**MEMORANDUM**

To: Southwest Consolidated Zoning Board  
Fr: Paul Greeley, Deputy Director  
Re: Application No. SW-FDP-3454 (GA), Final Development Plan, Dupont/Danisco USA, 201 New Century Parkway, New Century AirCenter.

*Aerial View of Subject Property in Yellow. New cooling system in Red.*

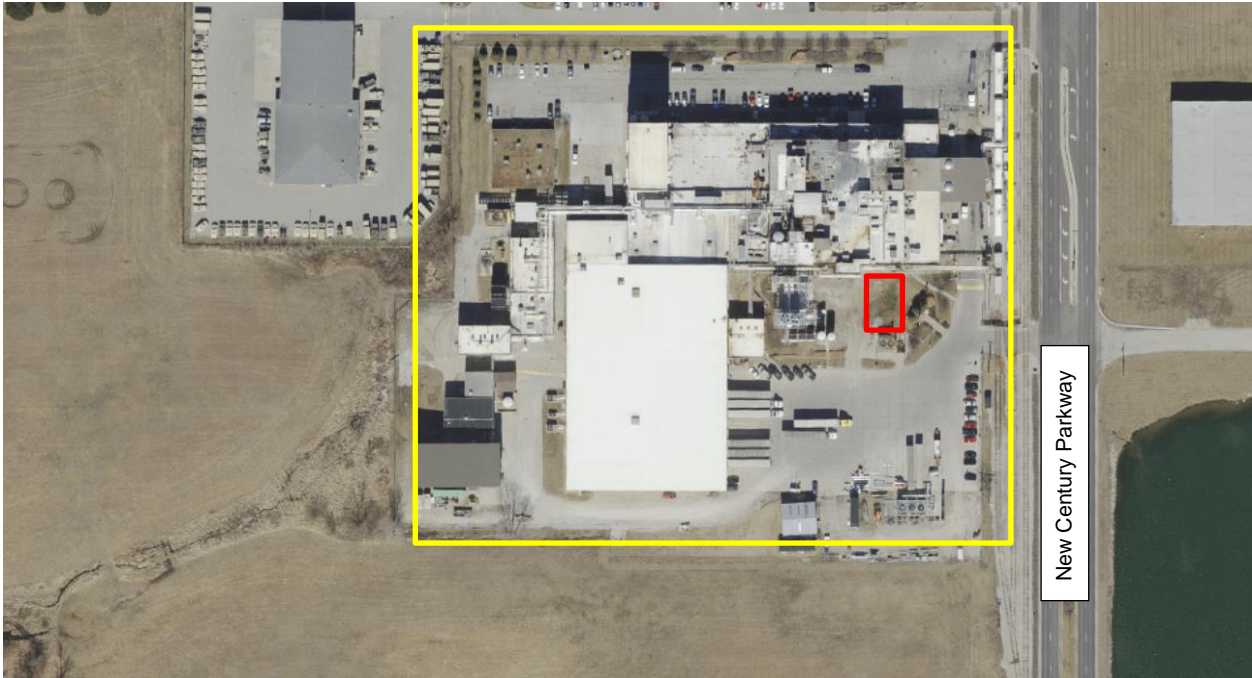
6. Screening. There is an existing large monument sign and trees located adjacent and on the street side of the new air cooling system location. Also, a 10 ft. tall slatted fence is proposed on the street side for additional screening. Both of which, satisfy the screening requirements.
